Access Compliance Report Public Rights-of-Way (Curb Ramps)

Main Street: TUBEROSE_ST		Cross Street: AGAPANTHUS_ST		Location:	SW
ADA ID: RPRK211111121616	Ramp Type: Type 4 - Parallel	Initial Pass/Fail: Fail	Overall Compliance: No	Severity Score:	16
Codes/Mitigation Info/Possible Solution			Field Measurements/Component Compliance

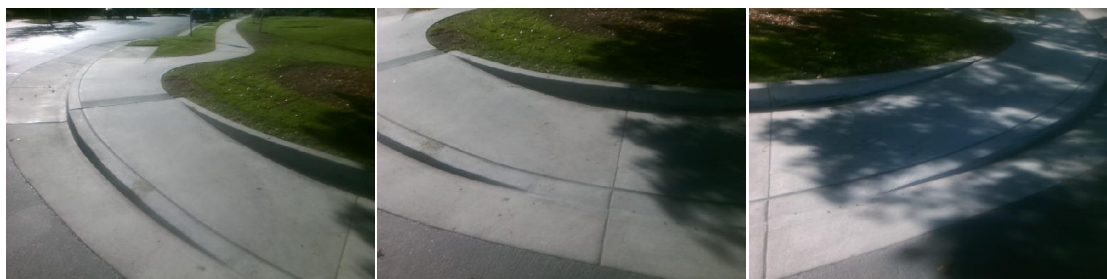
Compliance	Description	Data	Compliance	Description	Data
N/A	Ramp Length LT (in)	132	N/A	Ramp Length RT (in)	132
Yes	Ramp Width LT (in)	54	Yes	Ramp Width RT (in)	54
No	Ramp Run Slope LT (%)	9.4	Yes	Ramp Run Slope RT (%)	4.4
Yes	Ramp Cross Slope LT (%)	1.3	No	Ramp Cross Slope RT (%)	2.9
N/A	Landing Present	N/A	N/A	DWS Provided	N/A
N/A	Landing Length (in)	N/A	N/A	DWS Contrast	N/A
N/A	Landing Width (in)	N/A	N/A	DWS Length (in)	N/A
N/A	Landing Run Slope (%)	N/A	N/A	DWS Full Width	N/A
N/A	Landing Cross Slope (%)	N/A		DWS Offset Type	N/A
N/A	Landing Movement Obstructed?	N/A	N/A	DWS Offset Left (in)	N/A
	Landing Movement Type	N/A	N/A	DWS Offset Right (in)	N/A
N/A	Landing Shared	N/A			
N/A	Clear Space	Yes			
N/A	Clear Space To Crosswalk (in)	N/A			
N/A	Marked Crosswalk 1	No	N/A	Marked Crosswalk 2	No
	Crossing 1 Direction	NE		Crossing 2 Direction	N
	Marked Crosswalk 1 Width (in)	N/A		Marked Crosswalk 2 Width (in)	N/A

Remove & Replace Curb Ramp With Two New Directional Ramps or Equivalent.
